Environmental Review Team Report

Laurel Lane Subdivision

Columbia, Connecticut

March 1980

Preliminary Subdivision Plan

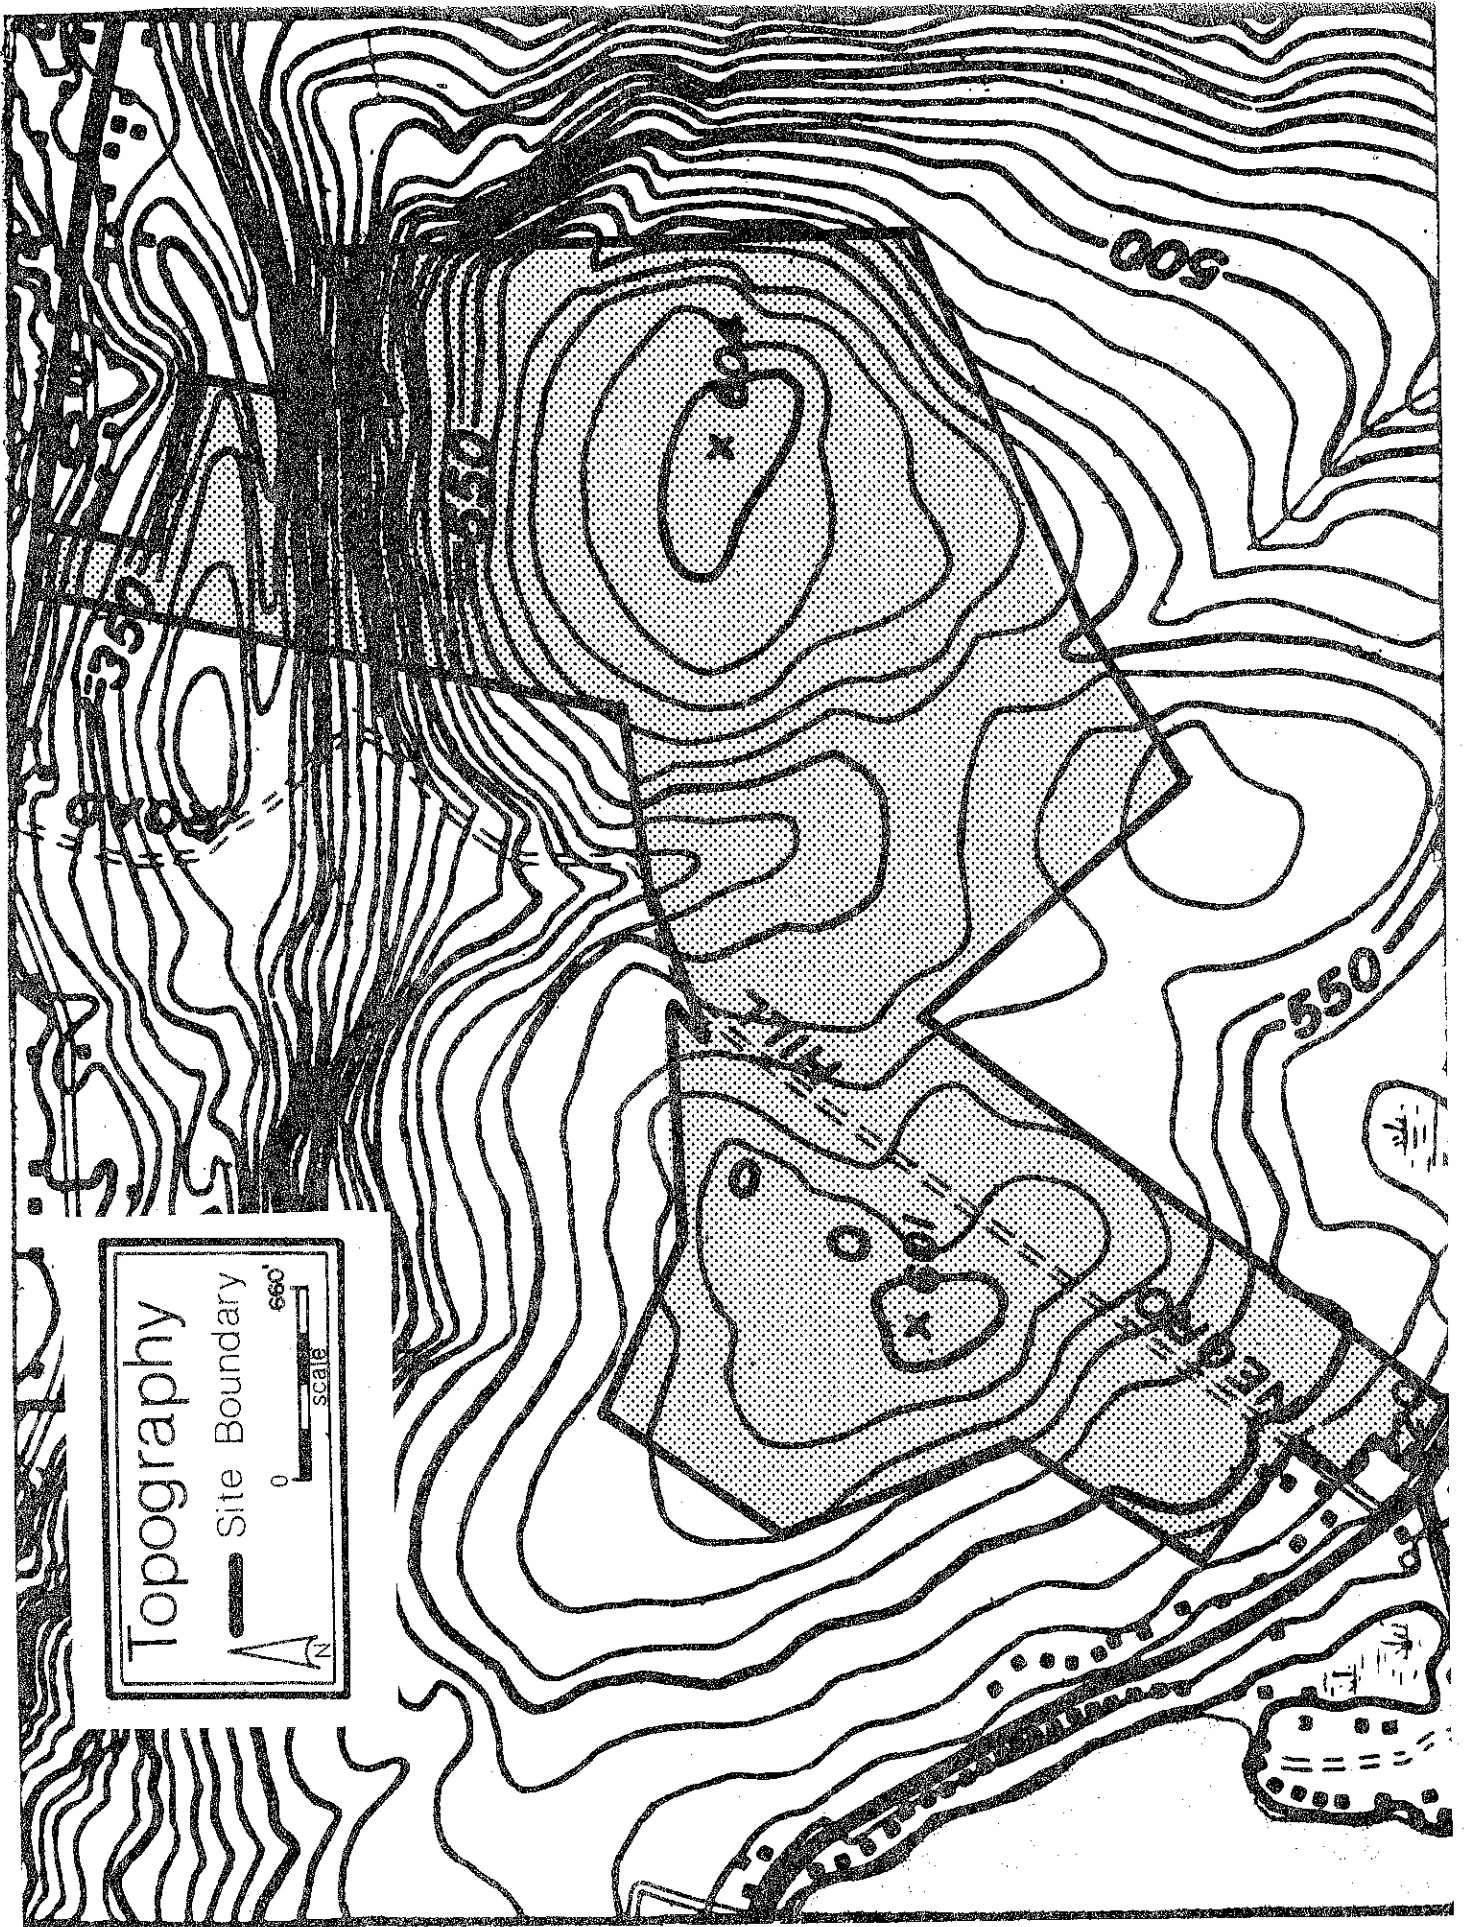
The preliminary plan shows 125⁺ lots on the parcel which would be served by on-site wells and on-site septic systems. An area shown as Open Space/Storm Water Management has been set aside in the wetlands area on-site. No lots have been shown in the area of excessively steep slopes. Access to the property would be provided by a single road (Laurel Lane) extending from Route 87 and a single access from Route 6 which ends in a cul-de-sac. Interior roads branching from Laurel Lane will form loops or end in cul-de-sacs. Most lots are directly fronting on one of these roads, however, several "back lots" do exist with a narrow frontage to the access road.

The Team is concerned with the effect of this proposal on the natural resource base of the site. Although difficult limitations on some sites can be overcome with proper engineering techniques, these measures are often costly, making a project economically unfeasible for a developer or landowner. The most critical problems evident from field review of this site are related to increase in storm water runoff, stoney and shallow to bedrock soil conditions, potential ground water contamination and traffic increases produced by the proposed development. Many of these potential problems can be controlled or avoided by lowering the density of the proposal.

Review of the plan shows that the central area between the two hills is very wet, and that this has been left as an open space-storm water management area. Development has also not been proposed for the extremely steep slopes at the northern part of the parcel.

Inspection of the property revealed large numbers of bedrock outcrops near the Route 87 end of Laurel Lane. It is felt that a large number of lots may not

be buildable in the lot #104 area. There are bedrock outcrops, wet areas, and steep slopes in other parts of the property also, and extensive soils testing will have to be done to determine the actual number of lots that can be considered buildable.

The condition of existing roads and highways serving the development is of critical importance. Approximately 120 lots in the initial plan are proposed to exit onto Route 87 via the very modest Laurel Lane. If fully developed according to the preliminary plan, more than 1,000 vehicle trips per day might be expected to take place on the lower portion of Laurel Lane on any given day (an average single-family suburban house generates 8 to 10 vehicle trips per day, i.e., 4 to 5 round trips; in the future that average might be expected to decrease somewhat as the cost of operation of a vehicle increases). In 1975, Route 87 in the vicinity of Laurel Lane carried an average of 2,000 vehicles per day. A subdivision of the scale of the one proposed would significantly increase the level of vehicle activity on the State highway. The subdivision will in no way tax the theoretical capacity of the State highway, although there are safety and convenience implications which must be addressed in any review.

Another critical consideration is Laurel Lane's intersection with Route 87. The Lane meets the highway at a curve and sight distances in both directions are restricted. In addition Lake Road, which is a natural extension of Laurel Lane, intersects Route 87 at an offset of 50 to 75 feet east from Laurel Lane. Any significant traffic between the two streets will likely generate considerable traffic hazards. Solutions to this geometric problem are available if, upon analysis, it proved to be significant. One would involve the relocation of Lake Road to the west to cross in front of an existing home to a point opposite the Lane. The home would clearly be negatively impacted. A second option would entail the construction of a new road east of Laurel Lane through a portion of the parcel under study. The road could be tied into Route 87 at the point of intersection with Lake Road with the acquisition of some additional private land which intervenes between Route 87 and the subdivision land. Provision for this second option could be made through the reservation of the appropriate land with actual construction reserved for some point in the future.

A large amount of the property has severe limitations for on-site subsurface sewage disposal. Although the 125-lot proposal leaves undeveloped areas which are wet and steep, it is felt that a large number of lots will be lost due to shallow depth of soil to bedrock. As stated, however, this is a preliminary proposal, and the actual number of lots possible will only be determined after extensive on-site soil testing.

Laurel Lane is inadequate to handle such an increase in volume of traffic; upgrading to contemporary road standards should be a prerequisite before any significant subdivision activity is permitted on the subject parcel. Such upgrading should be sensitive, however, to its impact on the existing homes along the road; appropriate adjustments to the road specifications should be made to reasonably minimize that impact.

In any event a detailed analysis of the traffic problems likely to be generated by a subdivision of this size should be provided for consideration by the Planning and Zoning Commission during the review of any final subdivision proposal.

WATERSHEDS - NO STORM DRAINAGE SYSTEM

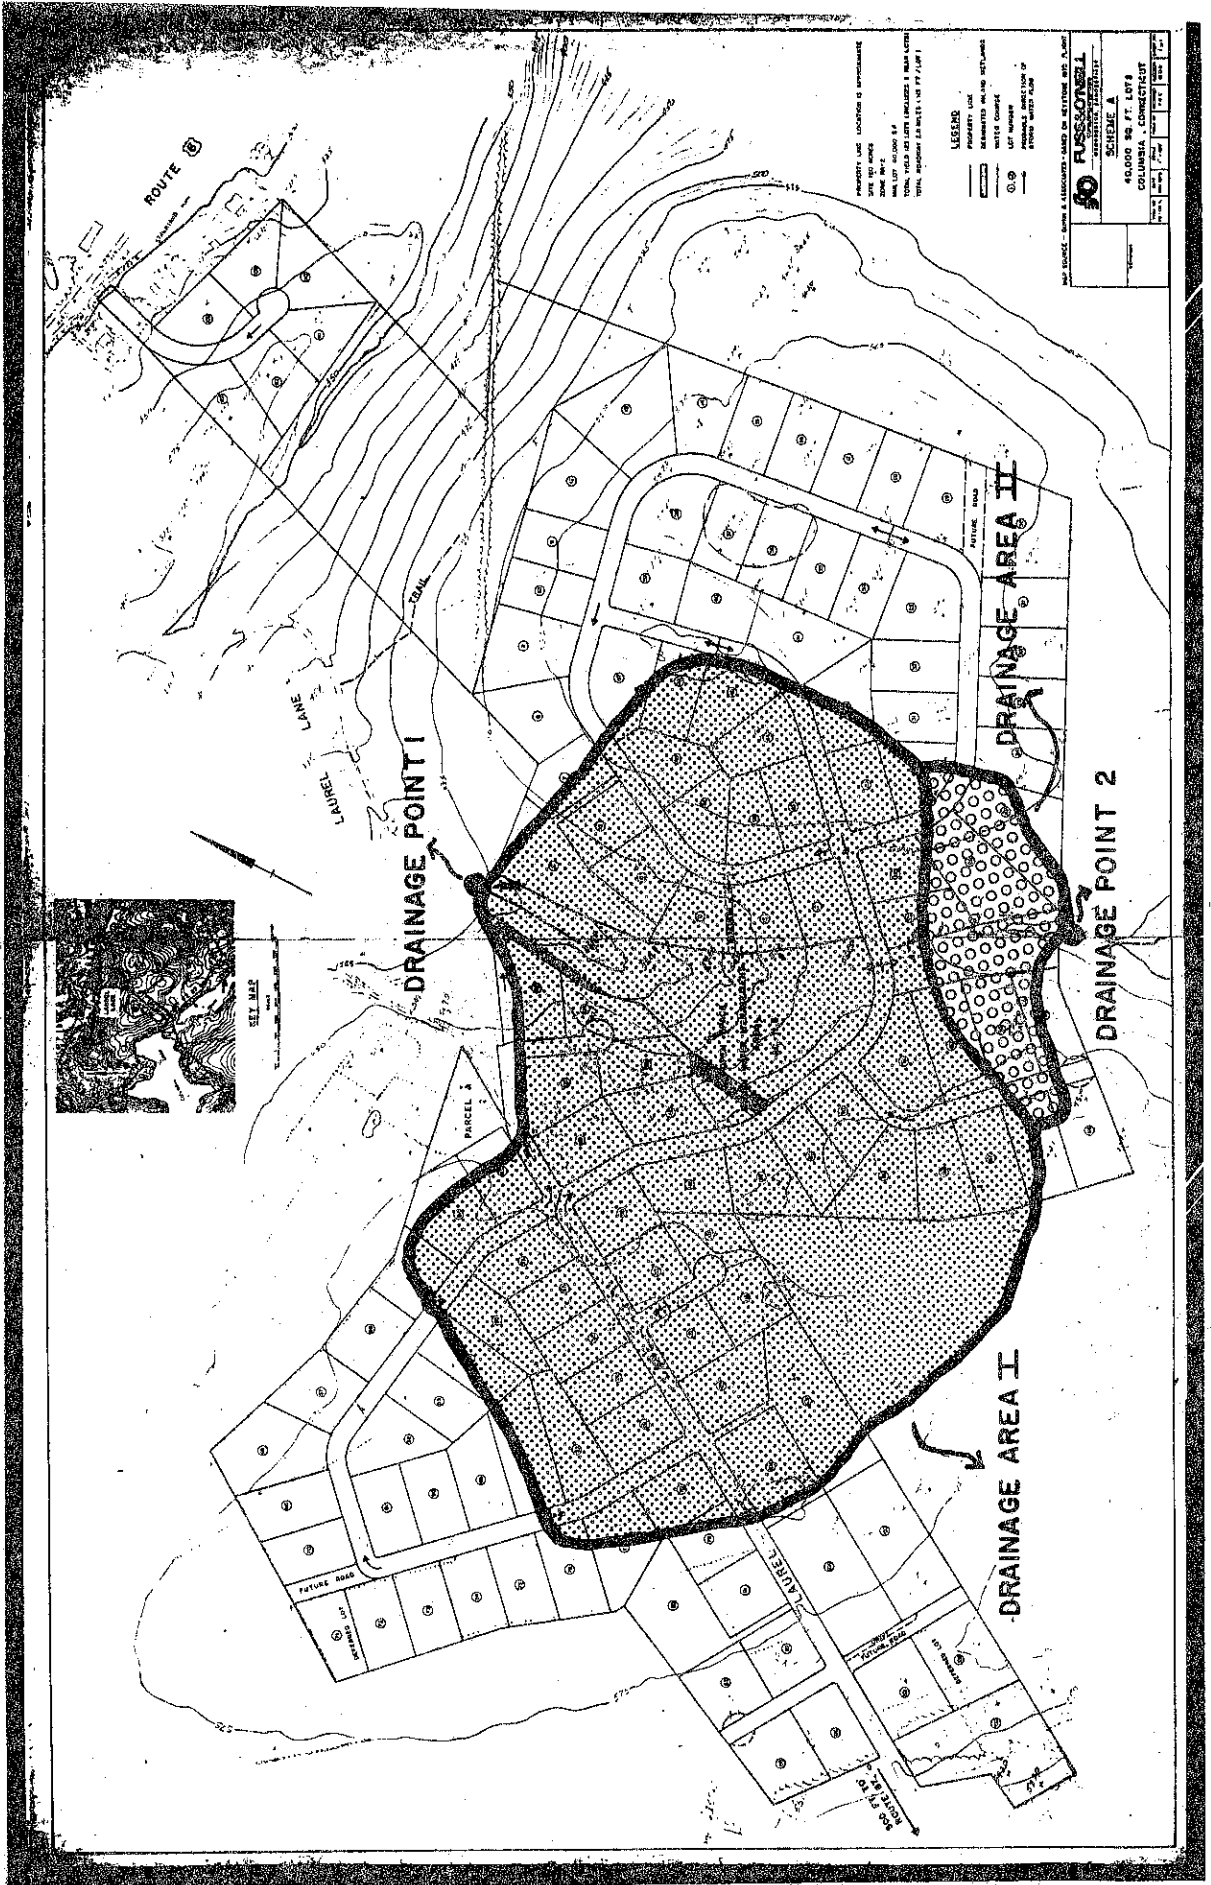
The proposed development is located on a hilltop that includes three broad peaks. Consequently, drainage flows in several directions from the site. Drainage to the north flows diffusely or in small channels, ultimately entering Hop River. Drainage to the east flows into Clarks Brook, a Hop River tributary that passes through a man-made pond approximately one mile downstream from the property. Drainage to the south flows either into Columbia Lake or into the wetland that forms the source of Dam Brook. Columbia Lake is tributary to Hop River, but Dam Brook is not.

Concern was expressed at the pre-review meeting about the potential effects of drainage from the proposed development, particularly in regards to Columbia Lake. Under the present topographic configuration of the property, a maximum of 14 of the proposed lots (lots 71-77 and 79-85) may lie within the Columbia Lake watershed. Drainage from lots 100-104 also flows southwestward along Laurel Lane, but this flow is intercepted by one or more catch basins along Route 87 and transmitted via a concrete conduit to the southeastern corner of the intersection of Route 87 and Lake Road, where it enters the Dam Brook watershed. Although the details of the road drainage network have not been submitted, it appears that surface flow from lots 79-83 will be effectively removed from the Columbia Lake watershed by piping the runoff from those lots to the eastern side of Laurel Lane. Groundwater in those lots would continue to be transmitted to the lake.

Because only generalized storm drainage flow patterns are shown on the development scheme submitted by the landowner's engineering firm (Fuss and O'Neill, Scheme A), it is not clear which way runoff from some lots would be piped. In particular, it is uncertain whether surface flow from a small drainage area consisting of lots 78, 86, 87, 95-99, and parts of lots 77, 88, and 94 would be channeled to the north or to the south. Peak flow estimates discussed below include both alternatives.

A representative from Fuss and O'Neill requested comments from the Team concerning the proposed storm water management areas. In response, the Team's hydrologist has estimated present and future peak flows for the 10-year, 24-hour storm and the 100-year, 24-hour storm at the points at which runoff from the northern

WATERSHEDS-STORM DRAINAGE SYSTEM, PLAN A

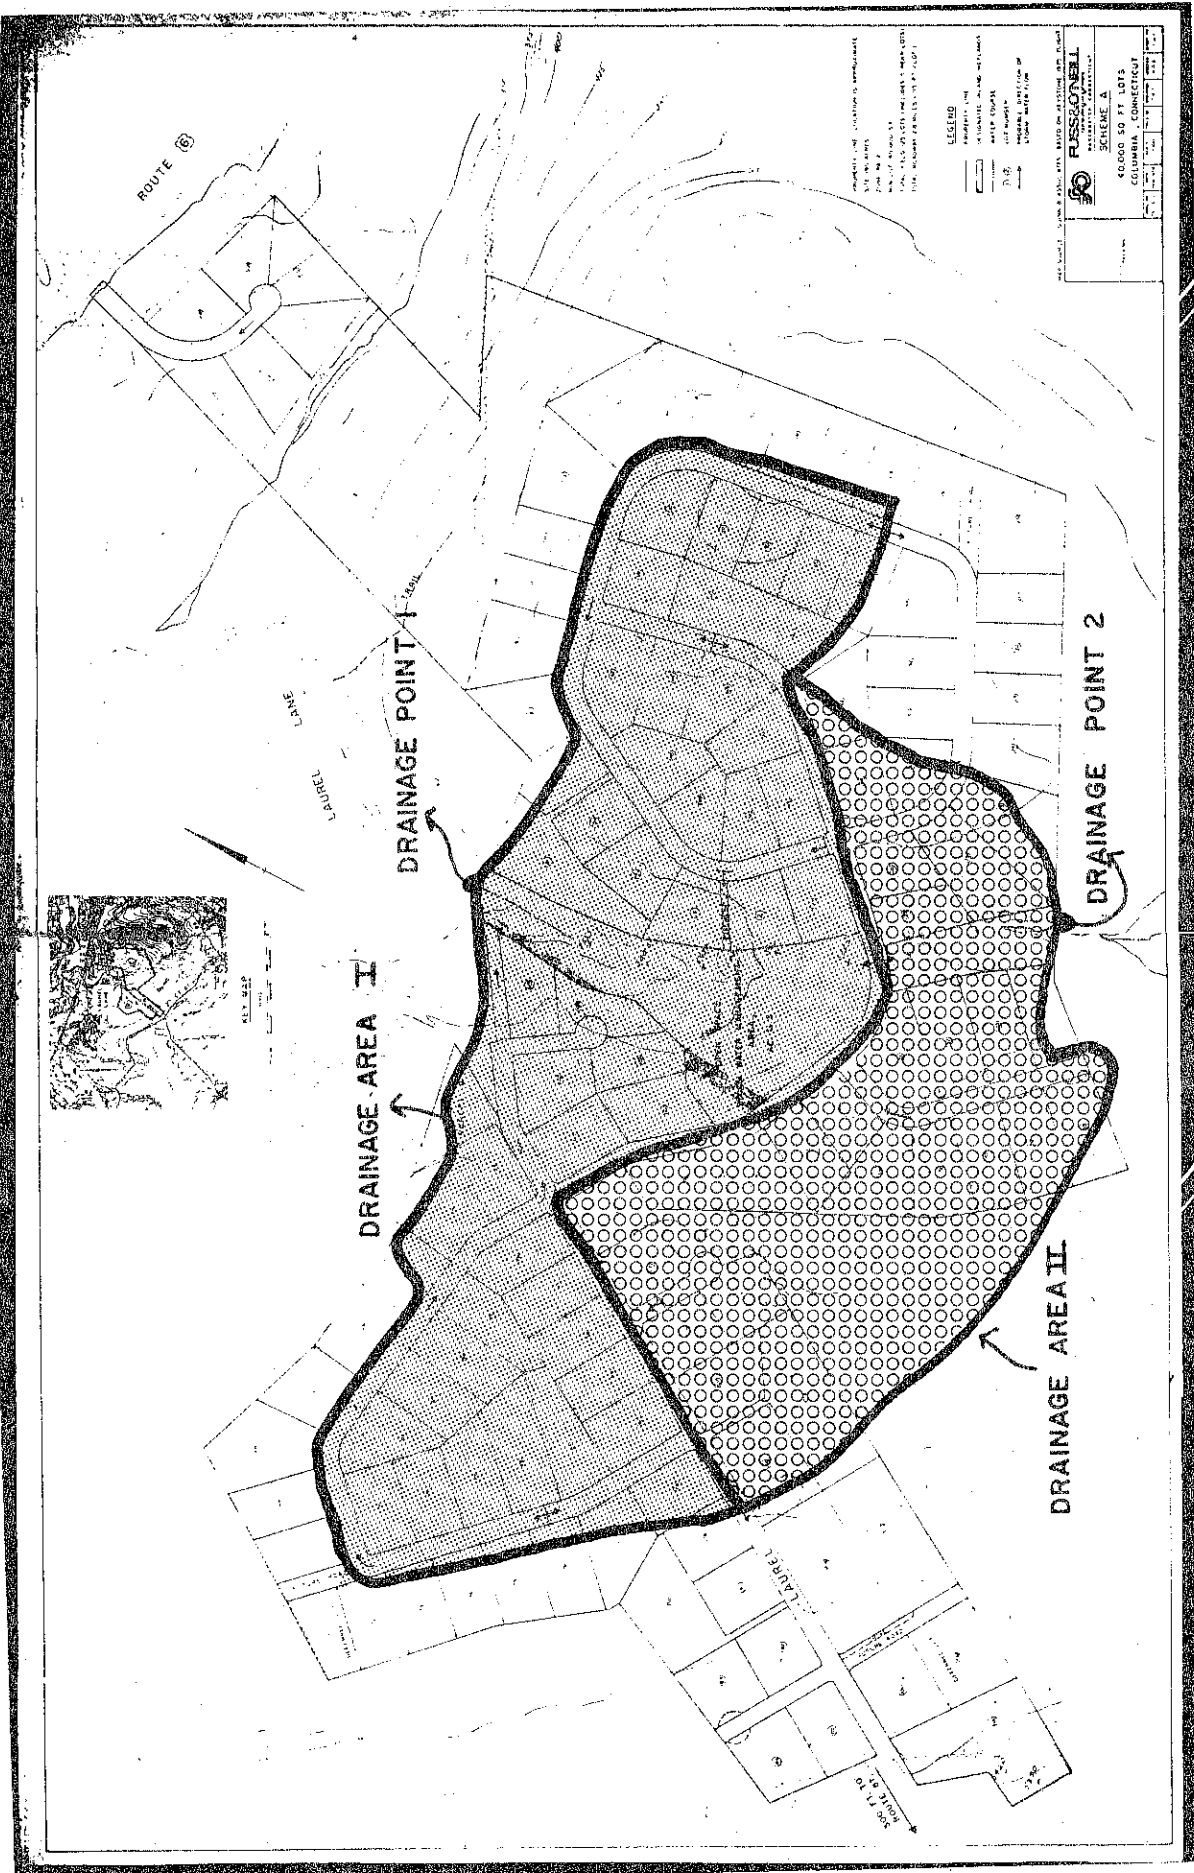
and southern management areas leaves the site. These estimates are based on incomplete data and are intended only to provide guidelines as to the anticipated magnitude of the peak flow changes; specific individual estimates are not intended to serve as the basis for engineering design purposes (e.g. pipe diameters). A table of the estimates follows. Maps accompanying this report show the approximate drainage areas for the two discharge points. All peak flows are given in cubic feet per second (cfs). Numbers in parentheses to the right of the developed condition peak flows indicate percentage increases in peak flows from the undeveloped condition.

As the estimates above indicate, the proposed development may lead to substantial peak-flow percentage increases. In particular, with the suggested storm drainage system in place, discharges at Drainage Point 2 may be approximately six to nine times greater for a 10-year storm and four to six times greater for a 100-year storm than they are at present. These very large increases would result in part from the redirecting of drainage from many of the lots. The storm drainage system would also, in turn, reduce the percentage increase in runoff at Drainage Point 1 from that which would occur under developed conditions in the absence of such a system.

Since the land immediately downstream from both discharge points is undeveloped, flooding hazards may not be as problematic as erosion and sedimentation. Nevertheless, the magnitude of the increases warrant consideration of retention basins in the stormwater management areas. Of particular concern are the present house lots on Oakwood Lane (north of the site) that are proximate to the discharge stream from the northern stormwater management area, and the house lots east of Thompson Hill Road (east of the site) that are proximate to Clarks Brook.

Erosion and sedimentation are clearly serious problems that, in themselves, warrant engineered flow-restriction techniques. On the steep slope north of the site, an enormous ravine has been eroded in the path of the unimproved section of Laurel Lane. The large peak flow increases generated by development may be expected to lead to similar problems unless some type of mitigating measures are

used. In addition to retention basins, slope stabilization methods should be considered for those areas in the immediate vicinity of any piped-discharge outlet.
